Royal Oak Community Association

Re: Referral Response: 520 Normandy Road (no project name)
Applicant: Aryze Developments Inc.
Saanich Planning Files: DPR00766 and REZ00647

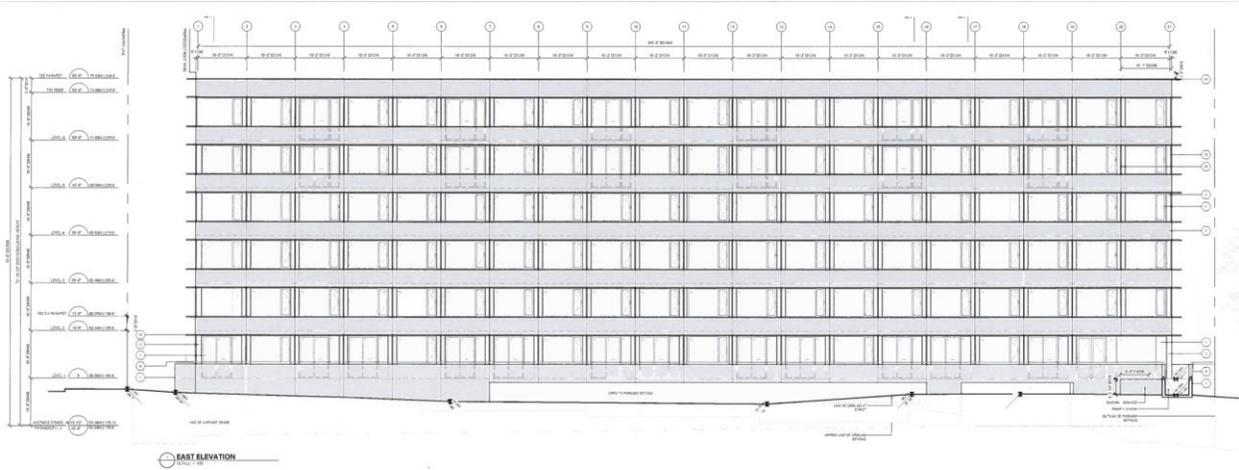
Additionally, the massive “big box” style of architecture would be greatly out of place with the existing quality and character of Elk Lake Drive and surrounding land uses. The block-long (20 apartment wide) 7-storey tower set hard against Elk Lake Drive, would dominate viewscales and be a jarring and overpowering landmark that is disrespectful to the surrounding Royal Oak neighbourhood. The nondescript long and narrow building very much has a stark institutional appearance, which is clearly illustrated in the attached comparative images attached at the end of this document.
